Subject: Oconee Nuclear Station
Docket Nos. 50-269, -270, -287
Oconee Reload Design Methodology Technical Report

OCONEE RELOAD DESIGN METHODOLOGY
TECHNICAL REPORT

RESPONSES TO NRC QUESTIONS
OF
OCTOBER 16, 1980

Figure 4-1. (FSAR Figure 14-1)

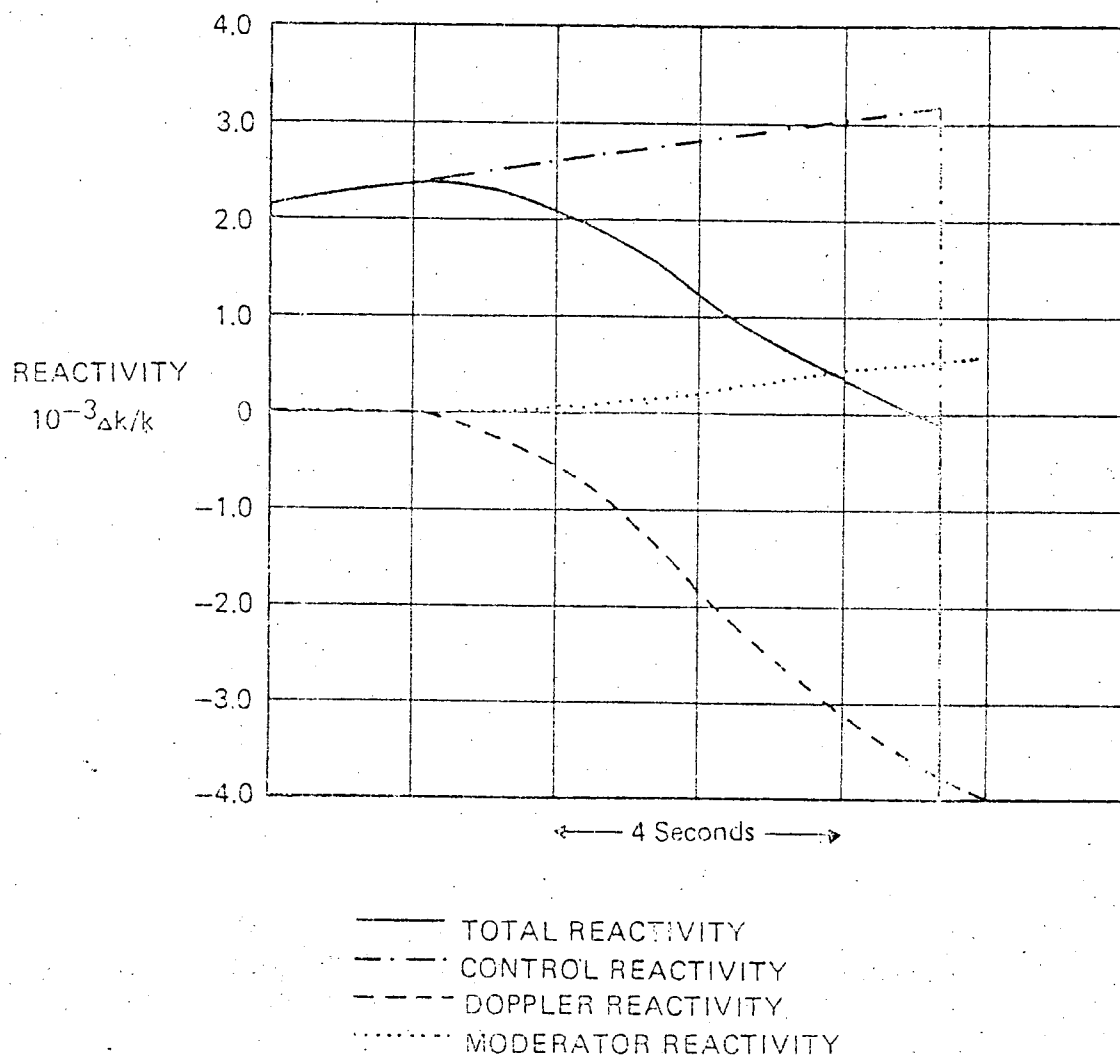
Q. 4. Paragraph 8.3.2. Start-up Accident

Give the variation of the total (and its components) reactivity for the start-up accident for the first 10 seconds after the accident initiation, (these would complement Fig. 14-1 and 14-2 of the Oconee FSAR Rev 16).

A. 4. The variation of the total reactivity during a start-up accident is the sum of three reactivity effects. The withdrawal of the control rod banks adds positive reactivity which causes the neutron power level to increase and raise the average core temperature. The increase in fuel temperature causes a negative reactivity feedback due to the negative Doppler coefficient. The increase in power level increases heat transfer from the fuel to the coolant, resulting in an increase in moderator temperature. This causes a positive reactivity feedback since a positive beginning of cycle moderator coefficient is assumed. The transient response is primarily determined by the rate of positive reactivity addition from the withdrawal of rods, and the Doppler feedback which slows or terminates the nuclear excursion. The moderator feedback has a smaller effect.

The reactivity response of the startup accident simulation performed by B&W and used in the original FSAR analysis is not available. In order to respond to the question, the variation of the total reactivity and its components were back-calculated from the results presented in FSAR Figures 14-1 and 14-2, utilizing the analysis assumptions specified in the FSAR. Using this method, the trends of the parameters of interest can be determined with a reasonable degree of accuracy. Figures 4-1 and 4-2 show the variation of the reactivity consistent with FSAR Figures 14-1 and 14-2 respectively. It should be noted that these figures do not represent the first 10 seconds of the transients, considering that the initial conditions are $10E-9$ rated power and 1% k/k subcritical. Figures 4-1 and 4-2 illustrate the time interval of greatest interest during the transient, Figure 4-1 is the same scale as Figure 14-1, and Figure 4-2 is the first one second of the response in Figure 14-2. For both transients the reactivity addition for the first 10 seconds following initiation of rod withdrawal would only cause a reduction in the subcriticality margin.

Figure 5-2 (FSAR Figure 14-9)

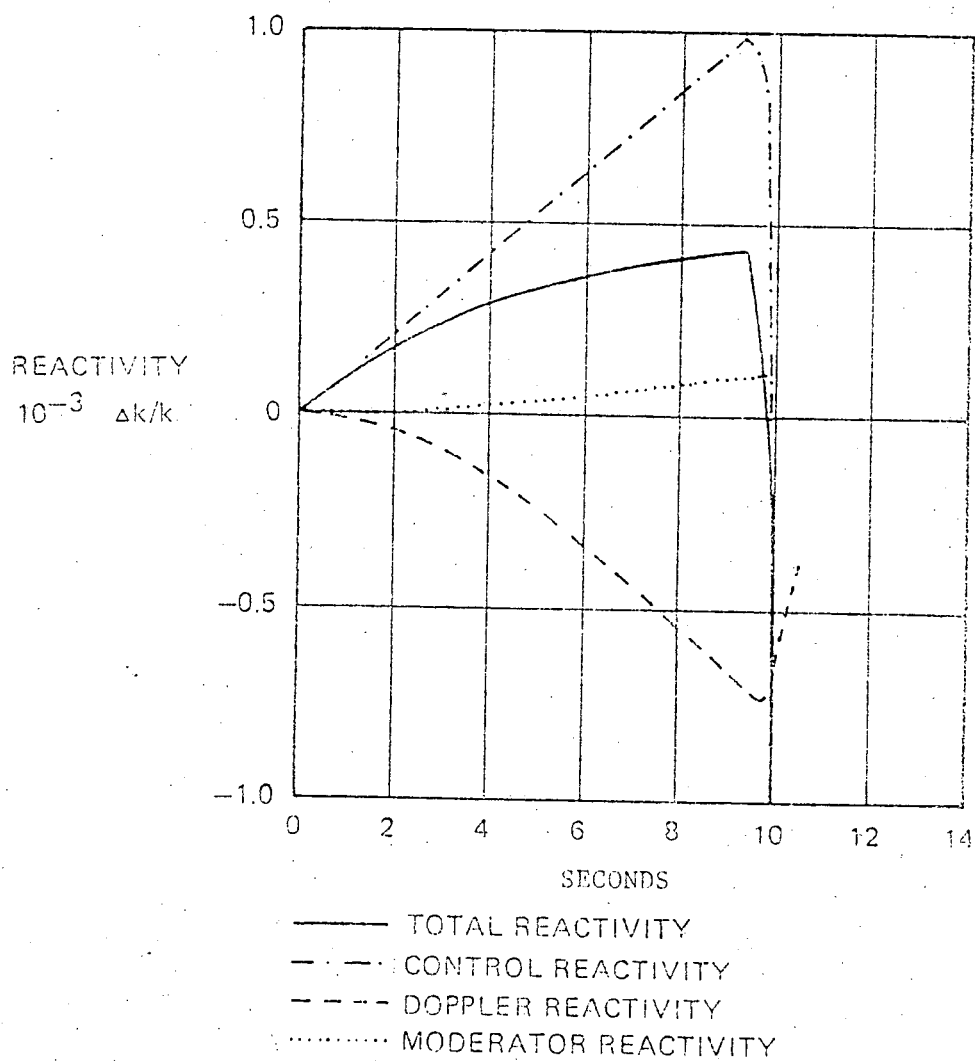
Q. 5. Paragraph 8.3.3. Rod Withdrawal Accident at Rated Power Operation

Give the variation of the reactivity as in 4. above.

A. 5. The reactivity response of the rod withdrawal accident at rated power simulation performed by B&W and used in the original FSAR analysis is not available. In order to respond to the question a similar analysis was performed by Duke Power Company using the RETRAN code and matching as accurately as possible the modeling assumptions of the original analysis. Figure 5-1, a revised FSAR Figure 14-9, shows the comparison between the original analysis (solid lines) and the new analysis (dashed lines). No attempt was made to match the results of the original analysis, the intent being to match the assumptions and initial conditions. The similarity between the results of the two analyses supports the conclusion that the reactivity response of the new analysis shown in Figure 5-2 is representative of the original analysis.
